**Subject:** Re: 13A Ocean road, Palm Beach - DA N0373/17

RE: 13a Ocean Road, Palm Beach  
Subject: **Development Application**

**REFERENCE: DEVELOPMENT APPLICATION NO. NO373/17**  
**ADDRESS: 13A OCEAN ROAD, PALM BEACH**  
**PROPOSAL: CONSTRUCTION OF A SECONDARY DWELLING**

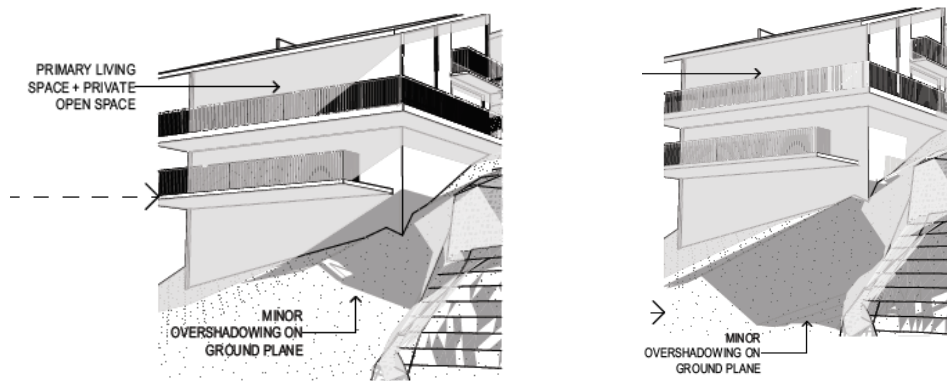
There consultant representing the southern neighbour has misunderstood the proposal.

There is no window in the master bedroom that faces south as stated in the objection. There is a highlight window in the living room with a sill at 2.65m above floor level. There are privacy blades on some of these highlight windows which are for the subject site's privacy from a site-line when standing on the neighbour's driveway.

The window in the bathroom that faces south will be frosted for mutual privacy and in any case, there is 3m in which to landscape between the bathroom window and the boundary line and a further 3m+ to the window line on the adjacent property.

Accordingly, the concern regarding privacy impact to the southern neighbour is ill-founded and we contend that the privacy impact to the southern neighbour is negligible.
